TSB 2014-1001 Level: 4 Effective August 15, 2014

Topic	Dye Injectors with the check valve installed in the wrong direction
Affected units	69702, 69703, 69705, 69706, 69788, 69789, 69950
Resolution	Return incorrect units for replacement

(Figure 3)

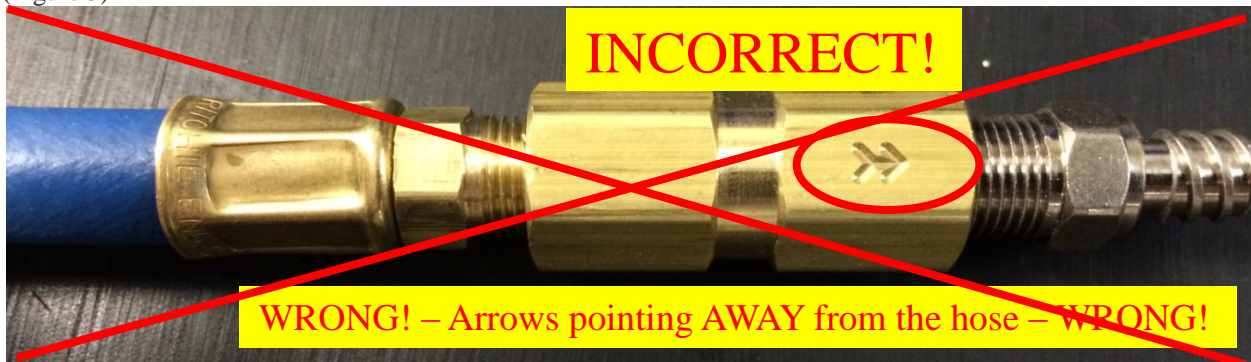
1. As seen in figures 1-3 you may or may not be able to see the arrows on the union with the check valve without opening the packaging.

- If you can see the arrows from outside the packaging they should be pointing towards the hose as seen in figure 3.

- If you cannot see the arrows on the check valve union through the packaging then you will need to remove the two staples holding the clamshell together and open it up to inspect it.
- After you have removed the hose assembly for inspection and found it to be ok; then carefully replace the contents back into the clamshell and secure with two staples.
- Any units that you find to have the check valve union installed incorrectly need to be returned to Ritchie Engineering under the RGA process. Reference this TSB. (TSB 2014-1001)
